## PCN

### Middle frequency welding for EPCOS M5 surge arresters

**Enclosure** PCN (ID No. PPD18/T122)

#### Comparison of welding designs

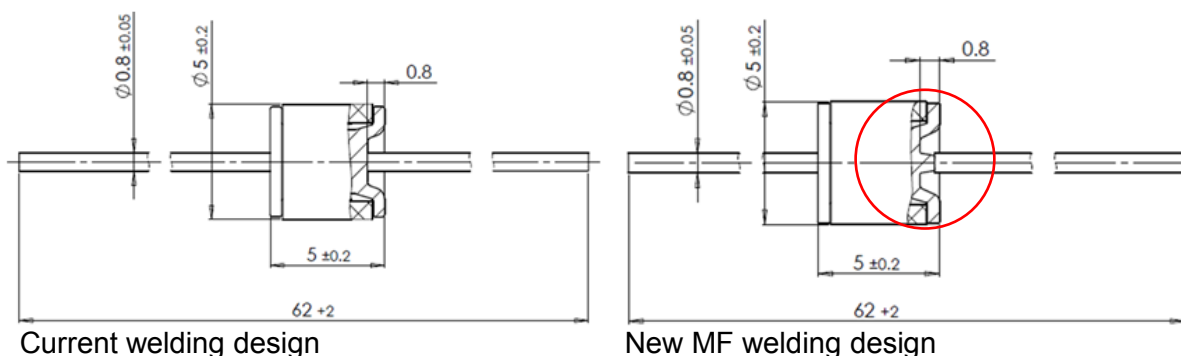
Middle frequency (MF) welding technology has now been qualified and internally approved for the EPCOS M5 series of 2-electrode surge arresters manufactured in the Xiaogan, China, plant. Copper (Cu) will be used as the base electrode material instead of iron/nickel (Fe/Ni). The dimensions of the components remain unchanged with the exception of very minor modification to the calotte of the outer electrodes. The plant in Xiaogan already introduced this MF welding technique in 2010.

All electrical and mechanical characteristics are unchanged. The type designations and delivery times likewise remain unchanged. The qualification was successfully performed according to ISO/TS 16949 requirements.
